MOONEY AIRCRAFT, INC.

Service Bulletin

NUMBER: M20-148

Installation of Rudder Seals.

Figure 1

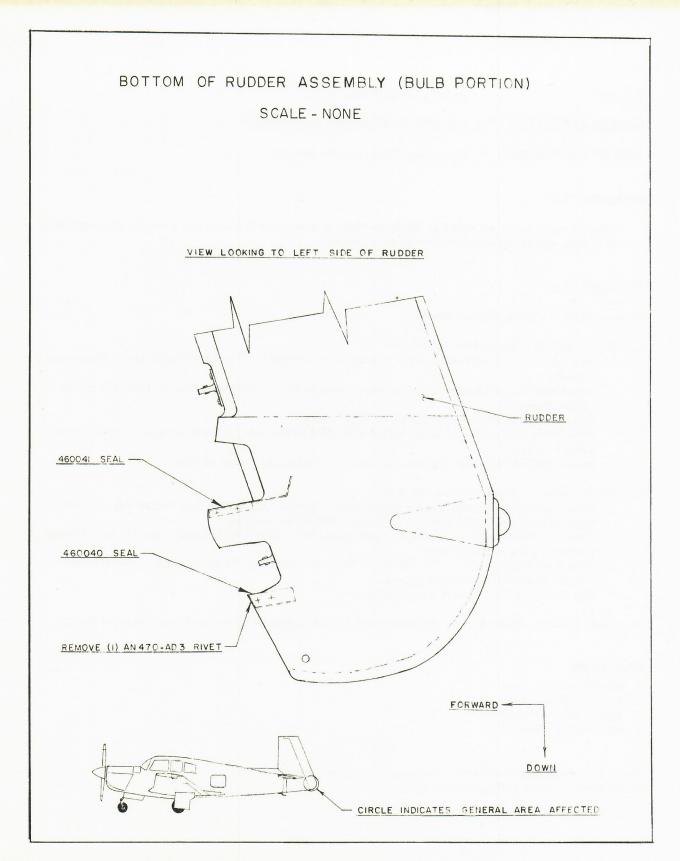
Two (2) seals are to be added to the lower (bulb portion) rudder assembly to reduce the possibility of foreign matter accumulating inside this assembly.

- I. Install 460040 Basic Seal as follows:
 - 1. Remove one (1) AN470-AD3 rivet-joining laps of 460023 7 and 9 'bulb' skin. (Reference Sketch).
 - 2. Insert seal-flanged upwards; locate approximately seven (7) inches from bottom edge of the rudder assembly.

- Edge of seal to be flush with edge of 'bulb' skins.
 - 3. Attach this seal to 'bulb' skins with AN426-AD3 rivets—one (1) each through available pilot holes on seal.

- 4. Install AN470-AD3 rivet (removed on item 1) 'picking-up' flange of seal.
- II. Install 460041 Basic Seal as follows:
 - 1. Insert seal-flanged down; locate approximately twelve (12) inches from bottom edge of rudder. Edge of seal and 'bulb' skins to be flush. (Reference Sketch).

- 2. Attach forward flange—this skin to 'bulb' skins with AN470-AD3 rivets one (1) each through available pilot holes on seal.
 - 3. Attach aft flange—this seal to 460033 Basic Rib with AN470-AD3 rivets* one (1) each through available pilot holes on seal.
